**ADDITIONS AND MAJOR RENOVATIONS AT  
HARVARD H. ELLIS TECHNICAL HIGH SCHOOL  
613 UPPER MAPLE STREET  
DANIELSON, CONNECTICUT  
PROJECT BI-RT-841**

<b>BID OPENING</b>	<b>1:00 P.M.</b>	<b>AUGUST 3, 2011</b>
<b>ADDENDUM NUMBER 3</b>	<b>DATE OF ADDENDUM</b>	<b>JULY 25, 2011</b>

## ROOF HVAC DUCTWORK PARTIAL PLAN - PART B

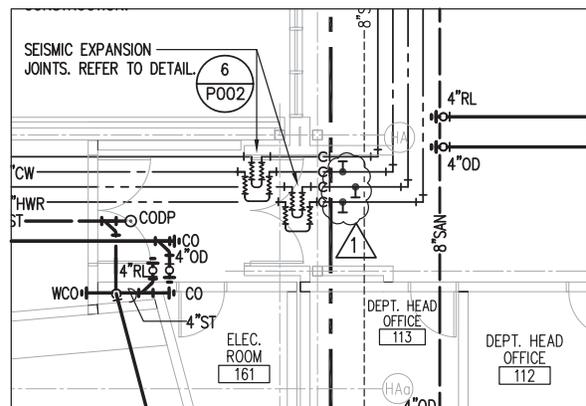
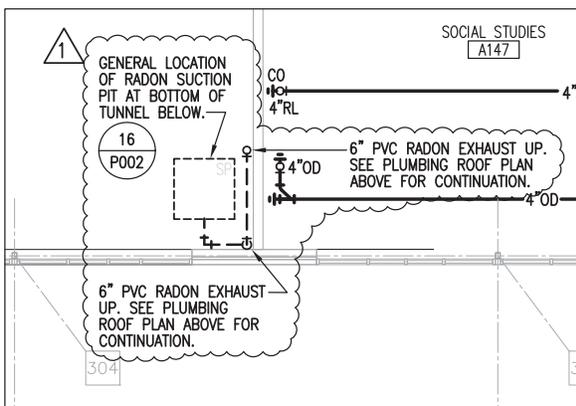
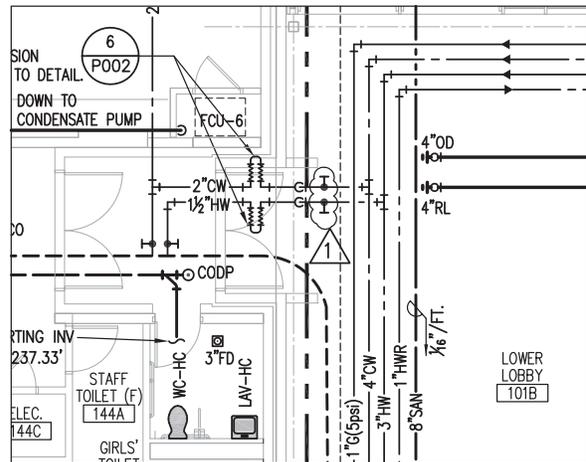
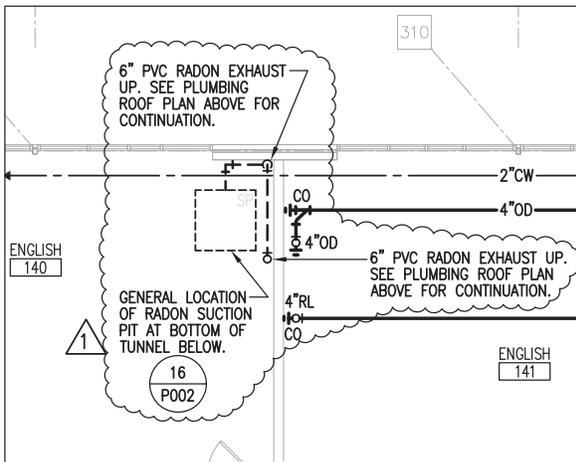
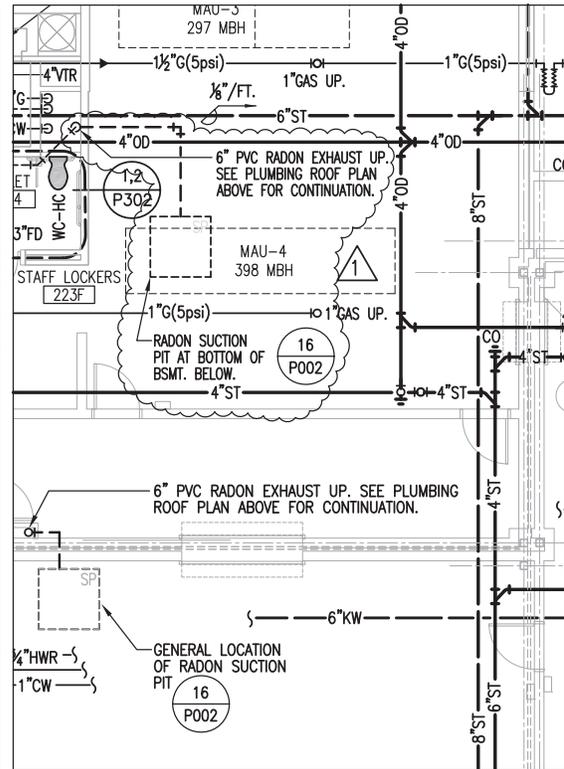
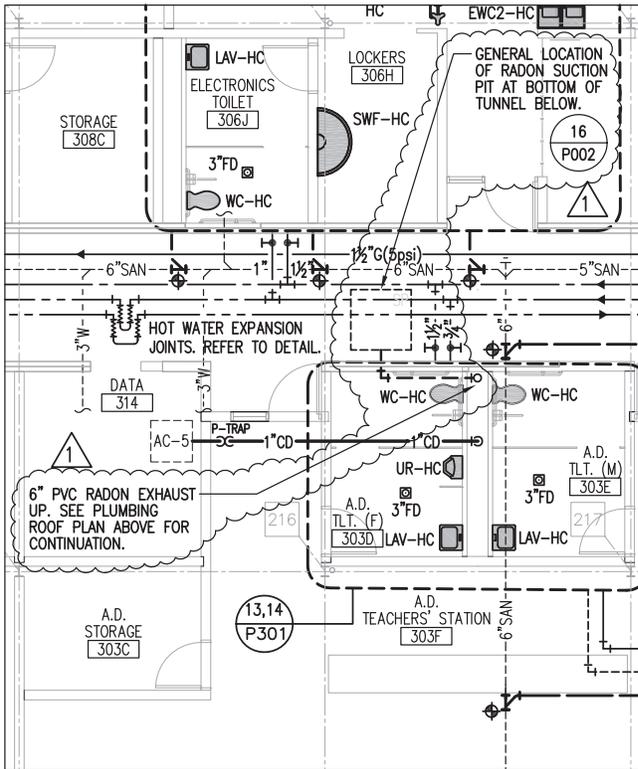
1. See Sketch SKM-42 –“Roof HVAC Partial Plan – Part B” – **ADD** radon exhaust fan RF-8.
